ROCKY FLATS SITE REGULATORY CONTACT RECORD 2015-04

Purpose: Mound Site Plume Treatment System (MSPTS) Reconfiguration Conceptual Approach

Contact Record Approval Date: July 8, 2015

Figure 1

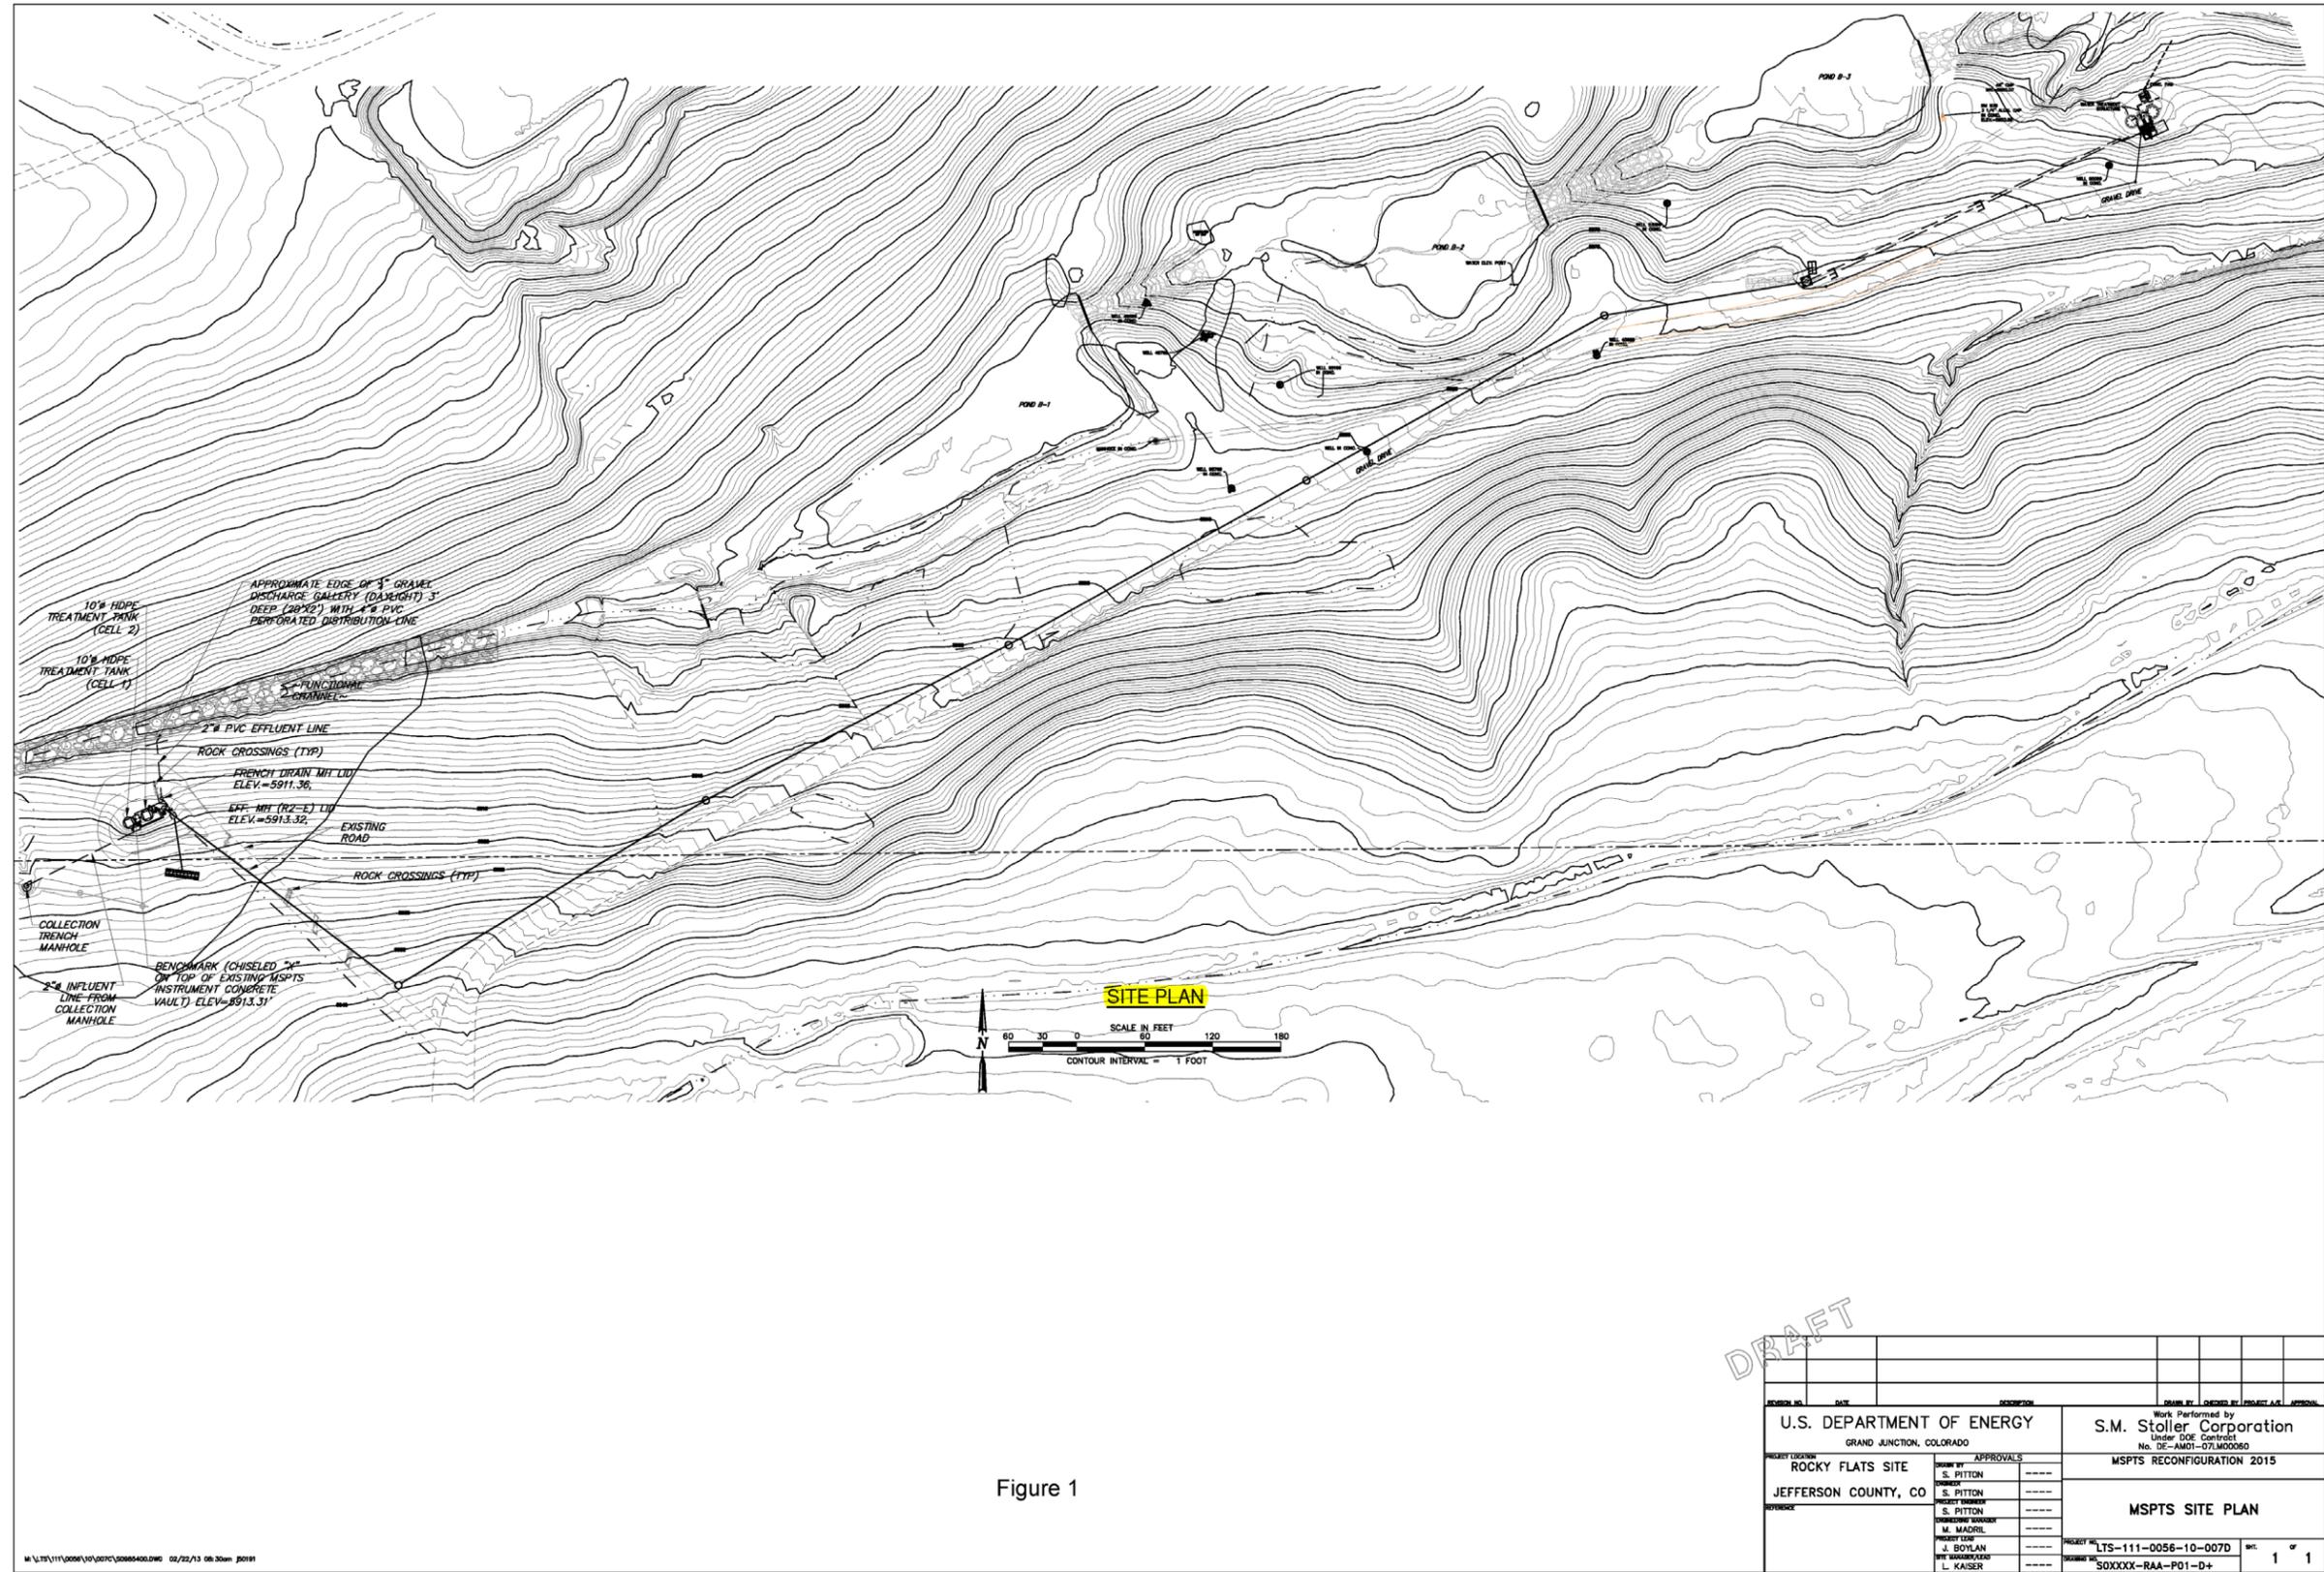
A conceptual approach has been developed and discussed among the RFLMA parties. This approach includes routing the MSPTS influent to the ETPTS air stripper; see Figure 1. The existing MSPTS tanks will initially be maintained and modified for optional water storage. The existing MSPTS effluent manhole will be replaced with a lift station and pump; water collected by the MSPTS will be pumped from this lift station to the ETPTS influent manhole. The combined MSPTS and ETPTS influents would then flow to the ETPTS influent tank and be pumped to the ETPTS air stripper in batches, just as is currently done with ETPTS influent alone. Additional solar power, piping, valves, instrumentation, and other necessary components would be installed to support this approach. Minor modifications to RFLMA Attachment 2 to reflect changes in MSPTS effluent and performance sampling locations have also been identified.

Resolution: It was agreed that DOE will prepare engineering designs for treating the MSPTS influent using the ETPTS air stripper. The RFLMA parties will consult in a timely manner on proceeding with the MSPTS reconfiguration to allow further planning and implementation as part of the MSPTS ZVI media removal project. Approval of the reconfiguration and of any required Soil Disturbance Review Plan for the work will be documented in a subsequent contact record.
